May 23, 2017
GZA File No. 05.0043654.00-C

Re: Site Investigation Report (SIR) Addendum
Former Tidewater Facility
RIDEM File No. SR-26-0934A
RIDEM Case Number: 95-022
Tidewater Street
Pawtucket, Rhode Island

SIR COMMENT LETTER

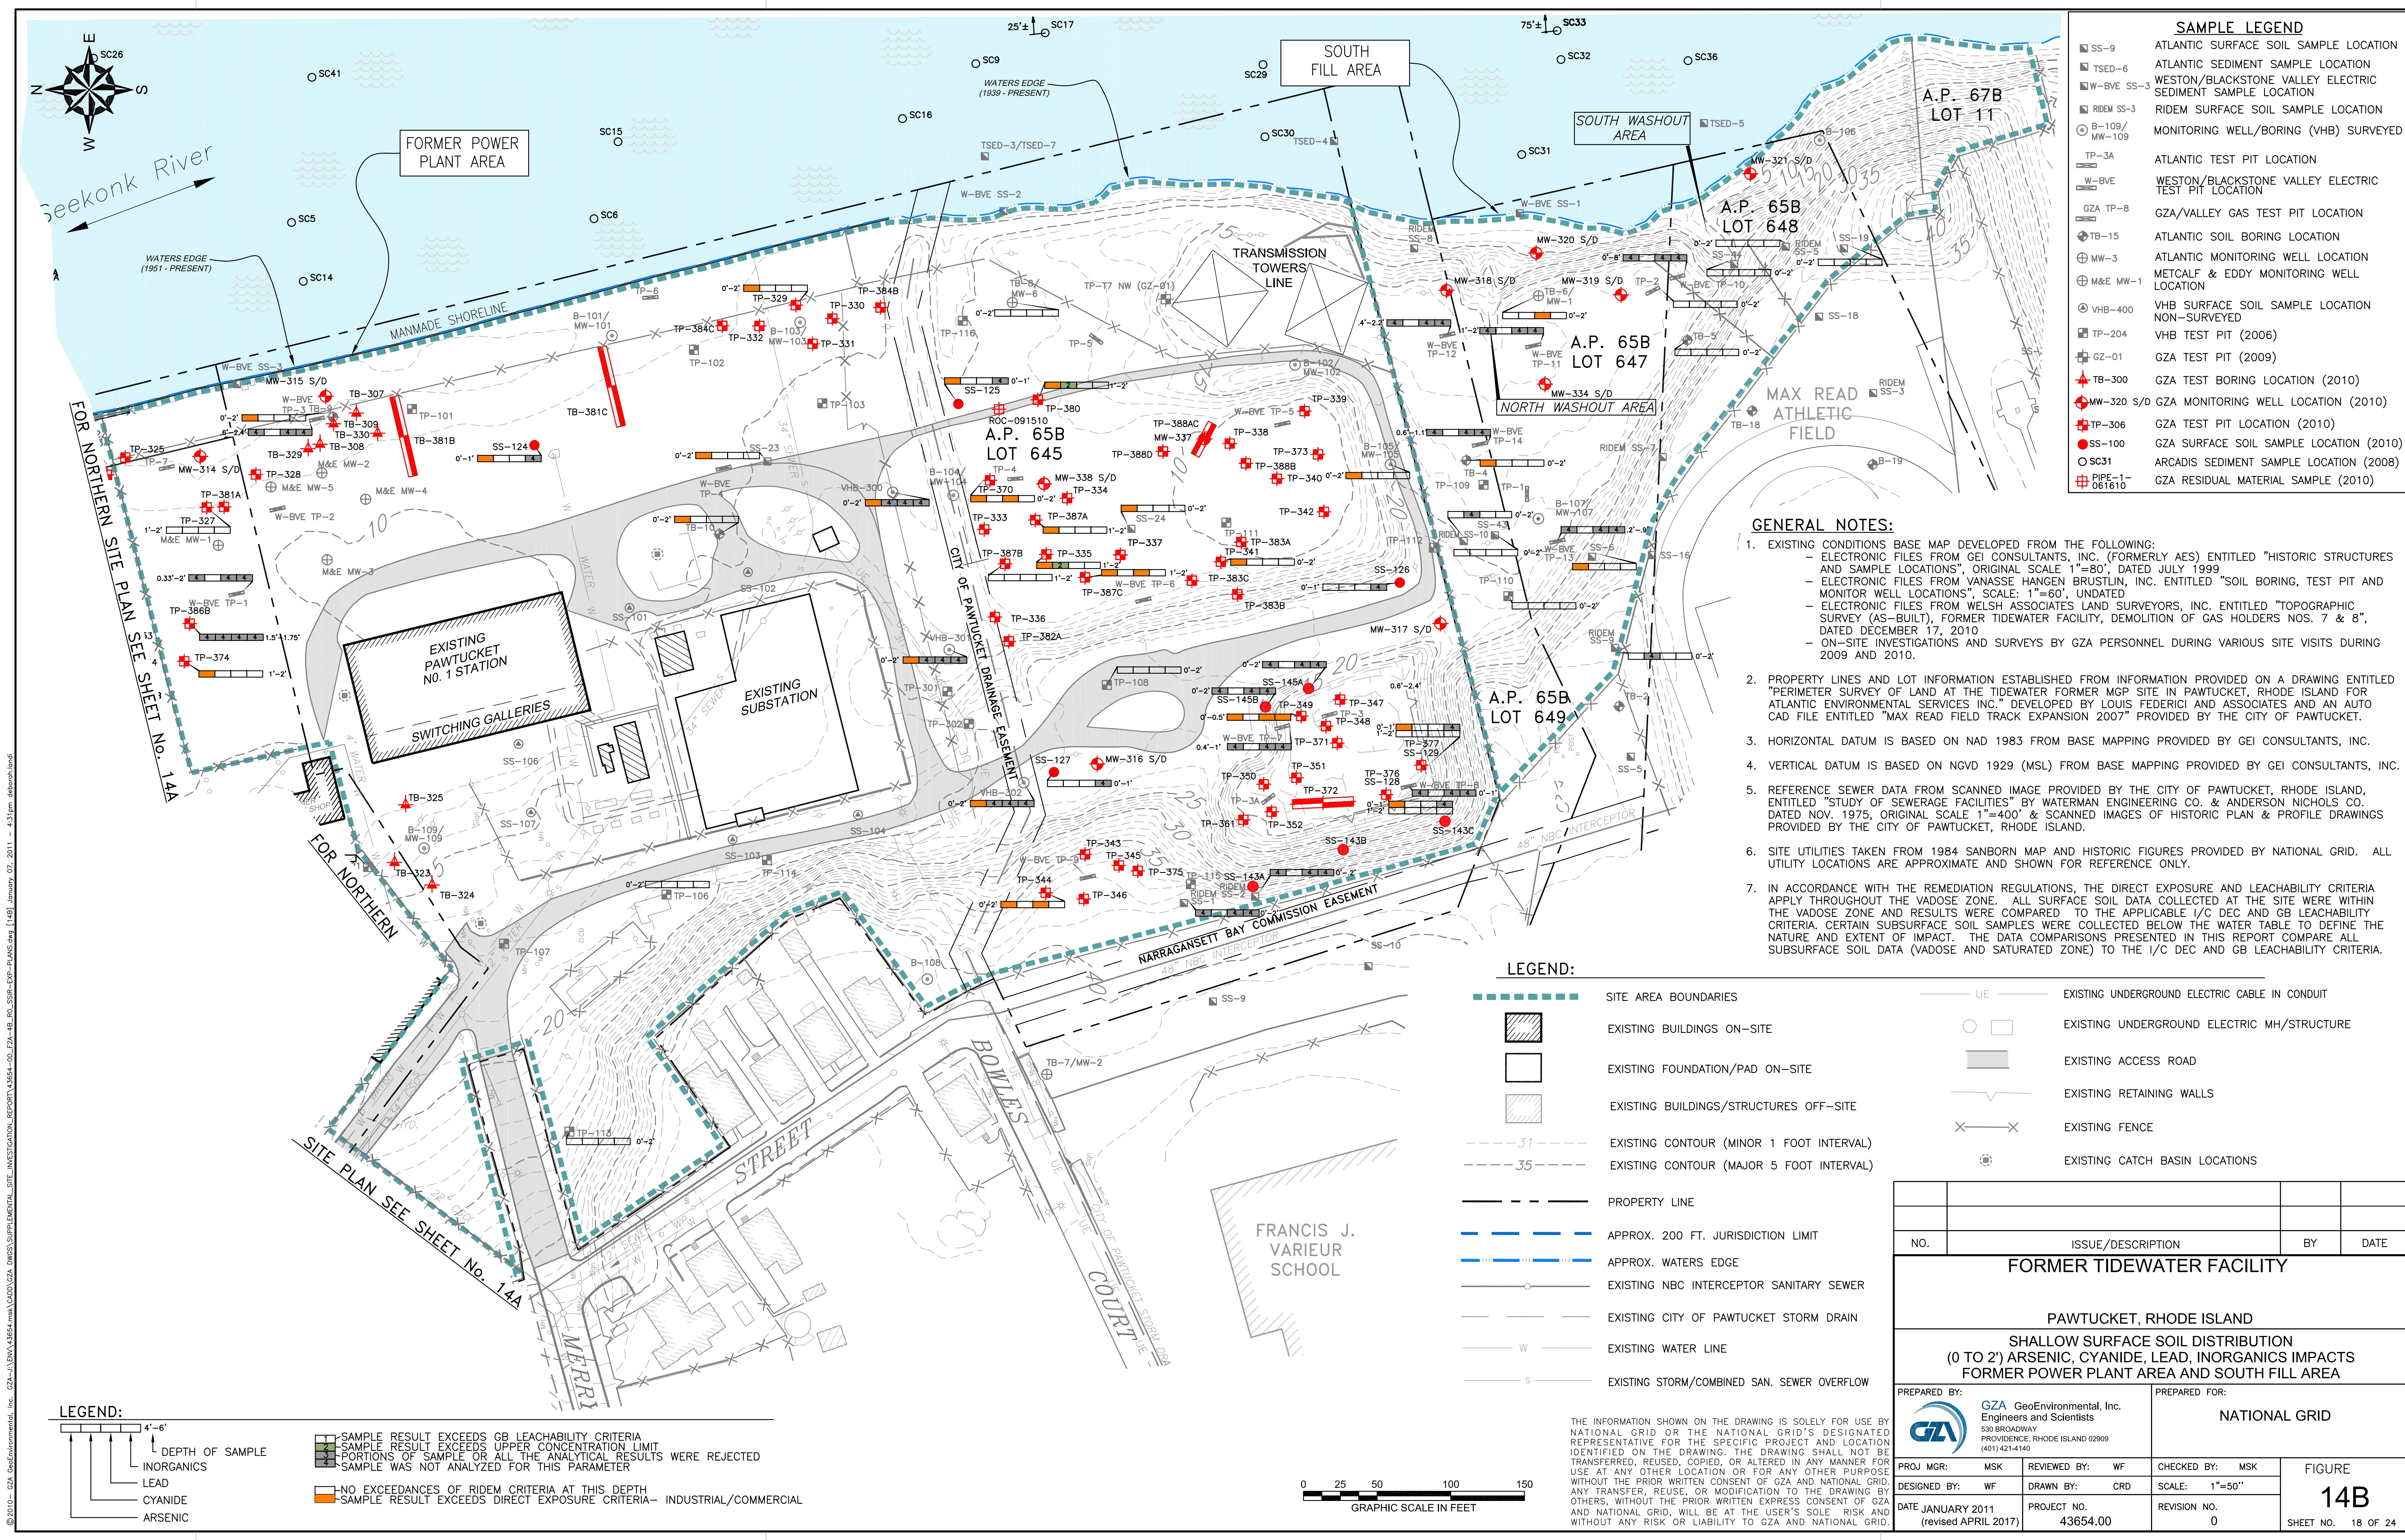
Regarding the January 11, 2011, Site Investigation Data Report (SIDR), Please correct the title of Figure 14B to replace the word "Subsurface" with "Surface."

See attached Figure 14B, Shallow Surface Soil Distribution (0 to 2') Arsenic, Cyanide, Lead, Inorganics Impacts, Former Power Plant Area and South Fill Area.

REMEDIAL ACTIONS

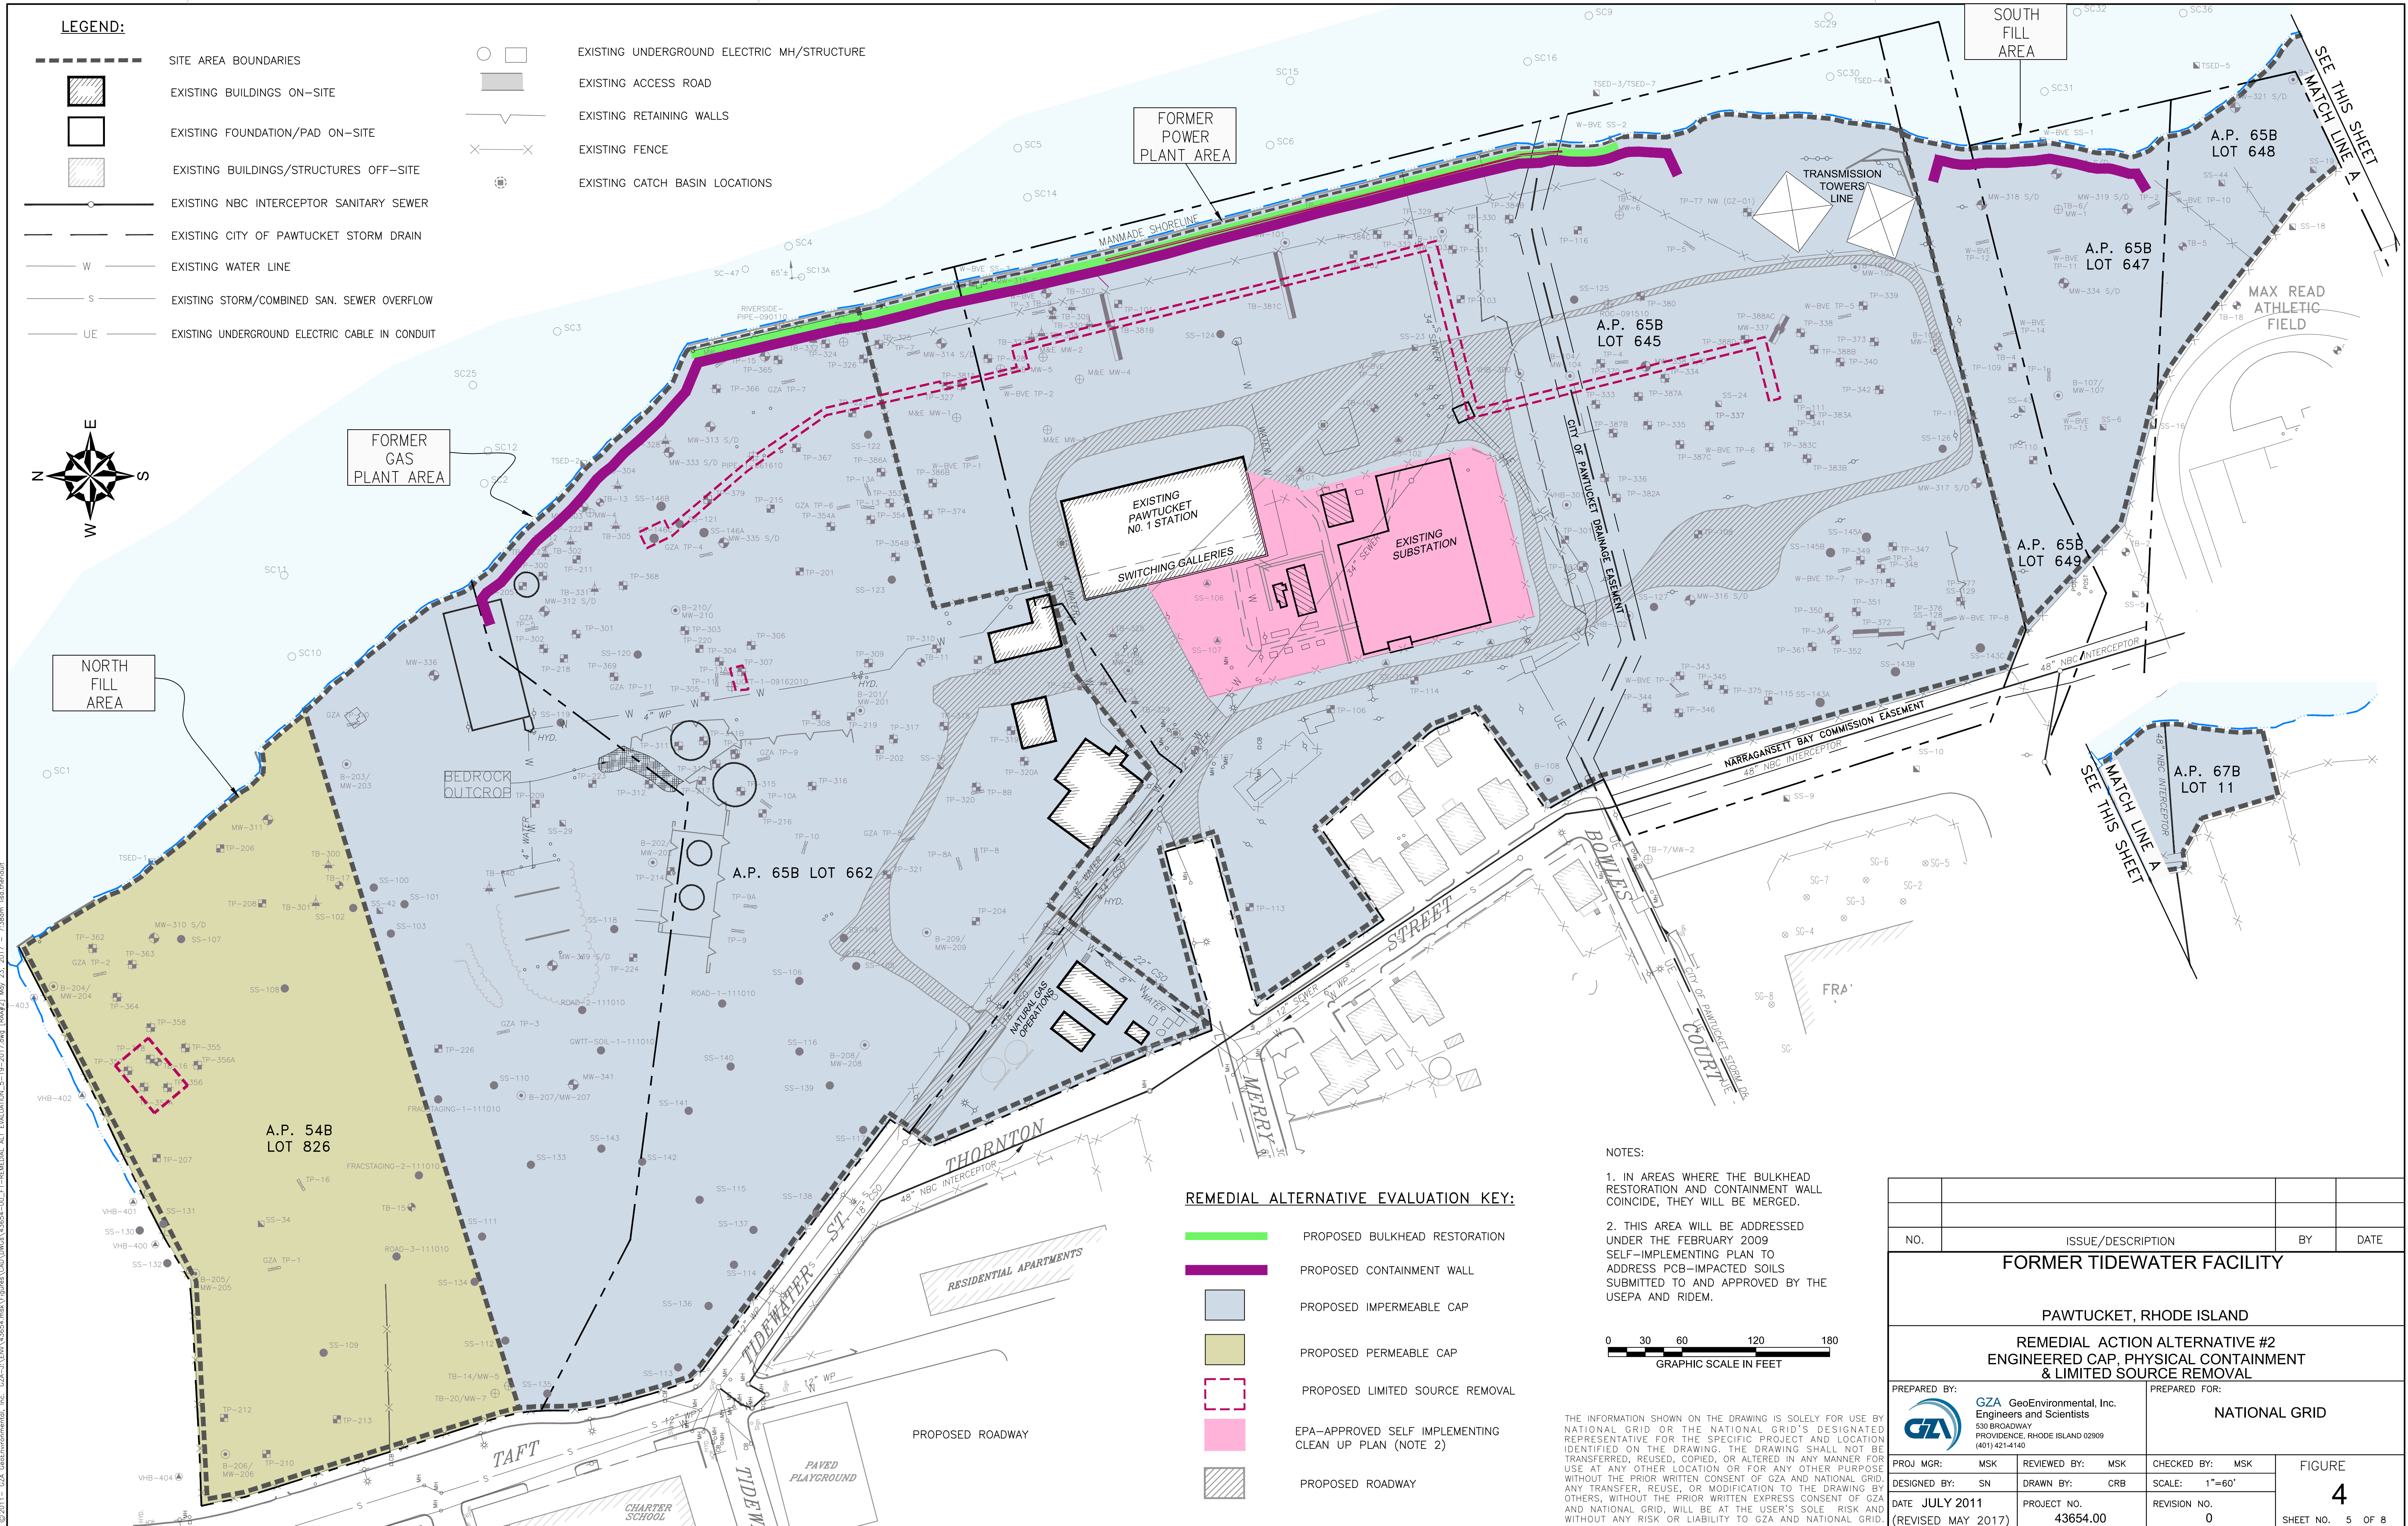
General Comment — Please provide a summary of all remedial activities completed since the RAER was submitted, and as applicable, how those activities may change the proposed remedy. For example, any areas of the Site that have been addressed through a Short Term Remedial Action Plan (STRAP) and therefore may not require additional remedial work.

The following presents a brief summary of remedial activities / projects that have been completed at the Site since the RAER was submitted on July 29, 2011. The attached Figure 1, Remedial Actions, shows the locations of each of these activities.
